SUBDIVISION REVIEW SHEET

CASE NO.: C8-2018-0217.4A

SUBDIVISION NAME: Colton Bluff Phase 3

CITY OF AUSTIN –DEVELOPMENT SERVICES DEPARTMENT SUBDIVISION APPLICATION – MASTER COMMENT REPORT

SHEET NO. 1 OF 3

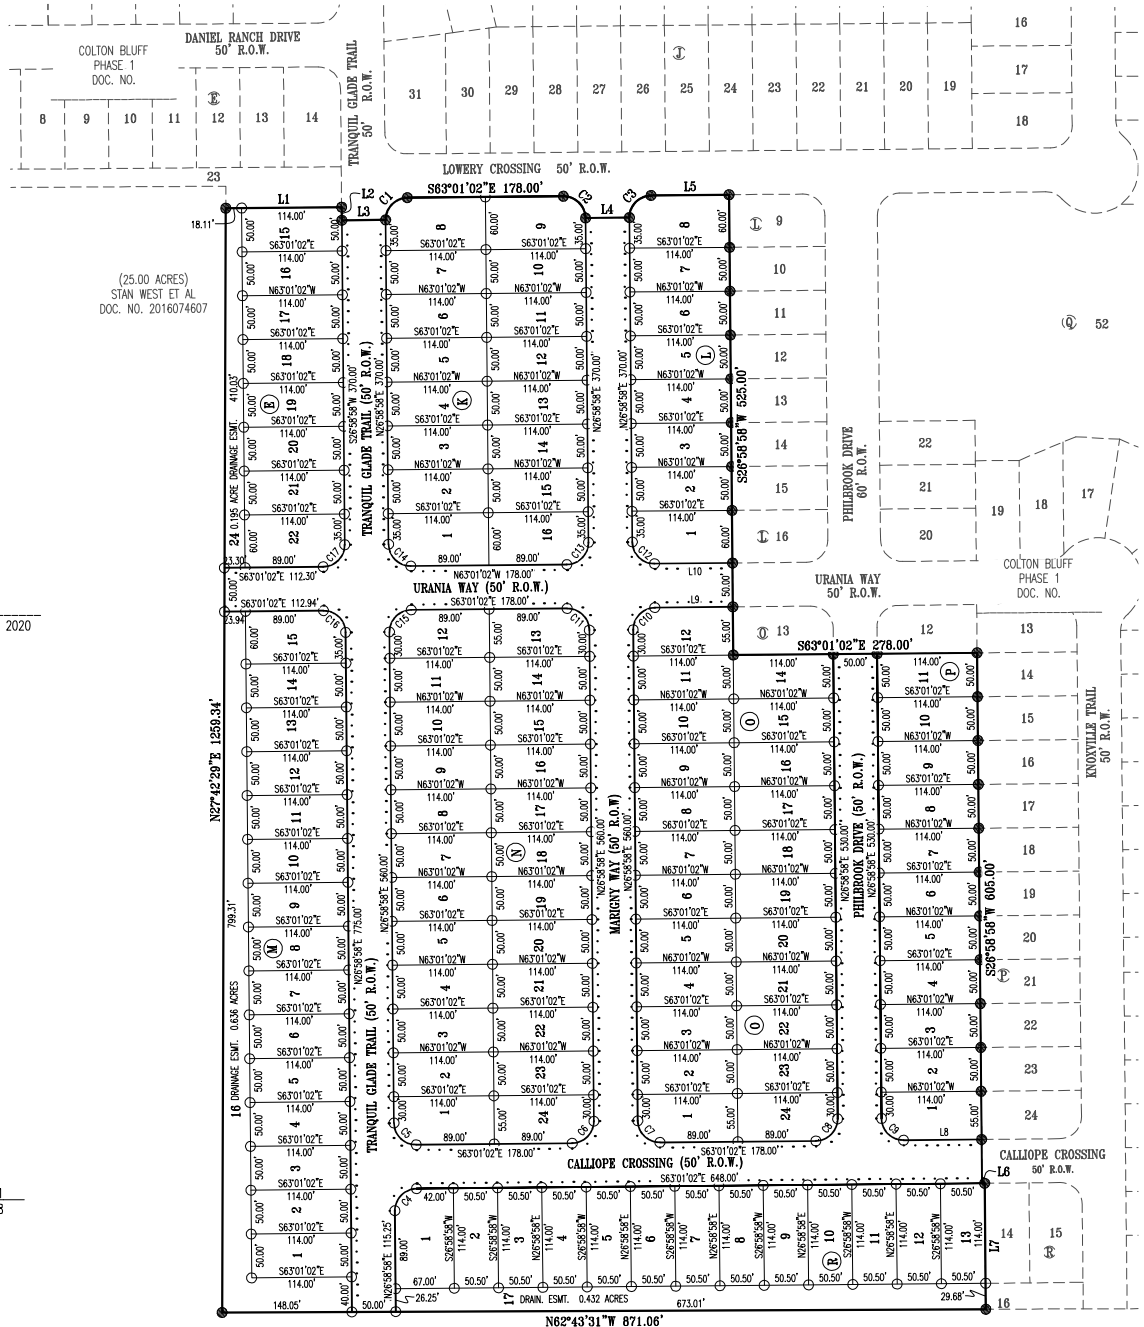
DE 1 Add a note showing the legal document that ties this subdivision to the pond the subdivision drains to.

WETL 1. This project does not comply with Critical Environmental Feature protection requirements. [LDC 25-8-281 or LDC 30-5-281; LDC 25-8-282 or LDC 30-5-282; ECM 1.10]. Additional information: Offsite wetland CEF standard 150 ft buffer encroaches within the property boundaries of this parcel. Please propose alternative wetland protection within the drainage easement shown in the plat.

Pursuant to compliance with Sections 307.1, 609.6, and 721.1 of the 2015 Uniform Plumbing Code, add a plat note that conveys the following: **Each Lot within this subdivision shall have separate sewer taps, separate water meters, and their respective private water and sewer service lines shall be positioned or located in a manner that will not cross lot lines.**

- SR 1. Add the Case #C8-2017-0217.4A in the bottom right hand corner of each sheet. 25-1-83
- SR 2. Add the document number of the recorded Homeowner's Document/Declaration of Covenants and Restrictions for Small Lot Subdivisions. 25-4-232
- SR 3. Revise the administrative approval block:25-18-3
APPROVED, ACCEPTED AND AUTHORIZED FOR RECORD BY THE DIRECTOR, DEVELOPMENT SERVICES DEPARTMENT, CITY OF AUSTIN, COUNTY OF TRAVIS, THIS THE ____ DAY OF _____, 20__, AD.

- SR 4. Because this plat may be approved by either the ZAP or the PC, revise the Land Use Commission approval block. 25-1-83
